# UNITED STATES PATENT AND TRADEMARK OFFICE

APPLICATION NO.	FILING DATE	FIRST NAMED INVENTOR	ATTORNEY DOCKET NO.	CONFIRMATION NO.
10/579,852	05/17/2006	Dietmar Van Der Linden	R.307220	8908

<b>Office Action Summary</b>	<b>Application No.</b> 10/579,852	<b>Applicant(s)</b> VAN DER LINDEN ET AL.	
	<b>Examiner</b> WILLIAM MCCALISTER	<b>Art Unit</b> 3753

## **DETAILED ACTION**

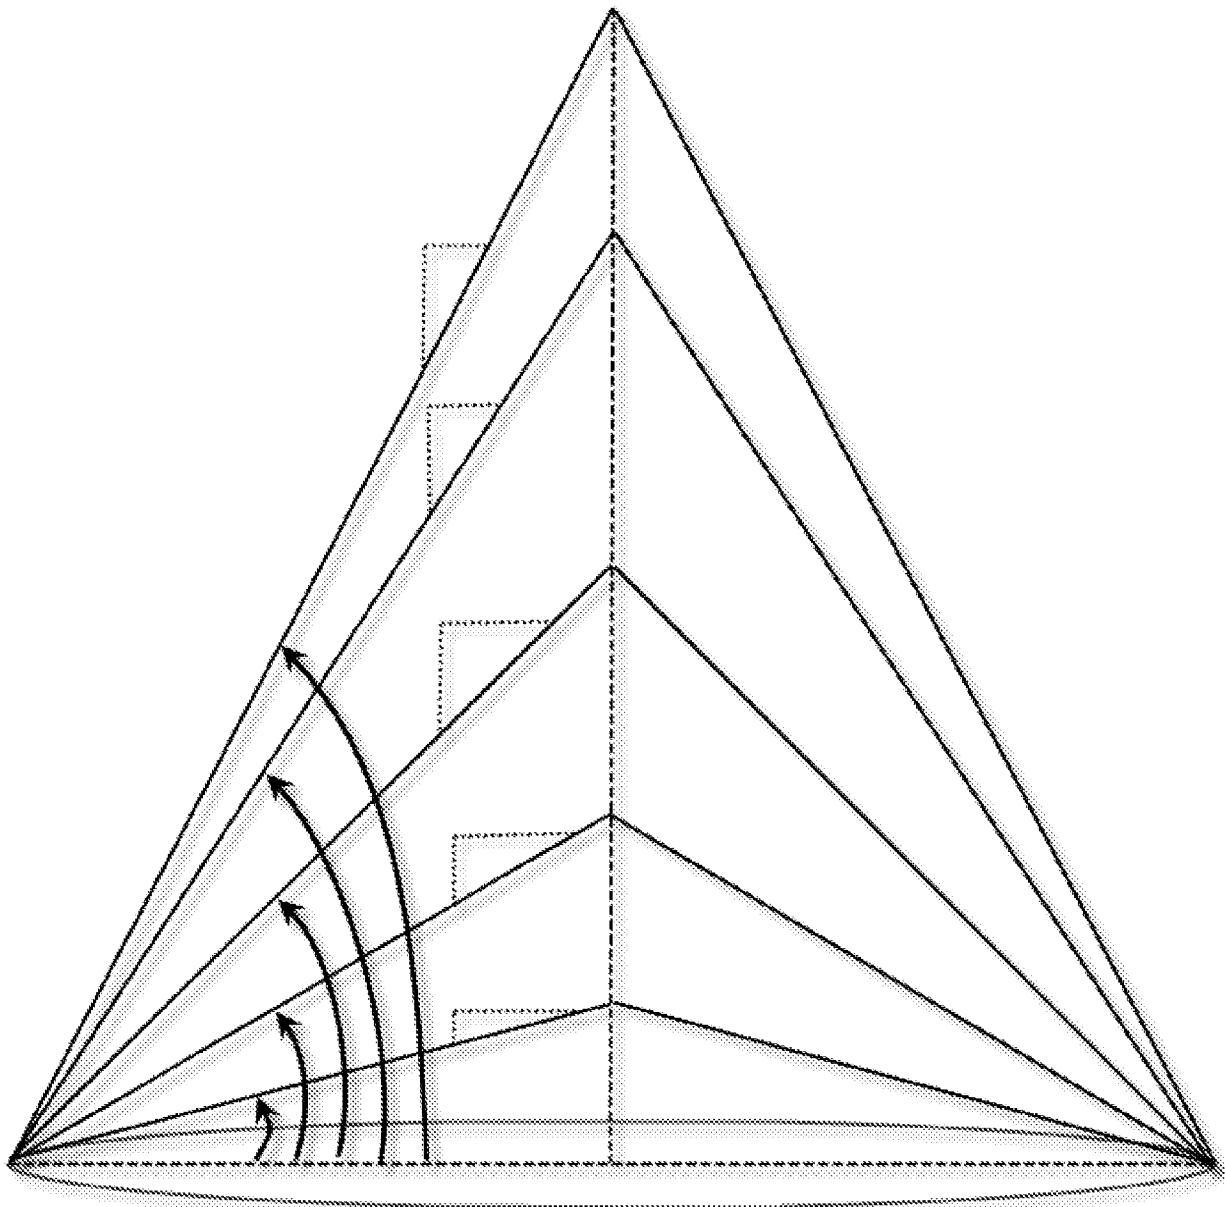
With reference to the figure below, note that as a cone's slope increases, the cone's base angle increases. A cone's base angle is considered a "cone angle" as claimed, under the broadest reasonable interpretation of this term.

Regarding claim 8, Talaski discloses (see FIG 8) a valve with a bore (14') of increasing diameter from left to right. Talaski discloses at least 5 conical surfaces (40) located along this bore, each formed of a section of a cone (see ¶ [0027]) which has a cone base angle (inherently, as illustrated above). In the direction of increasing bore diameter (from left to right, FIG 8), Talaski discloses these cone sections to have increasing cone slopes and therefore increasing cone base angles.
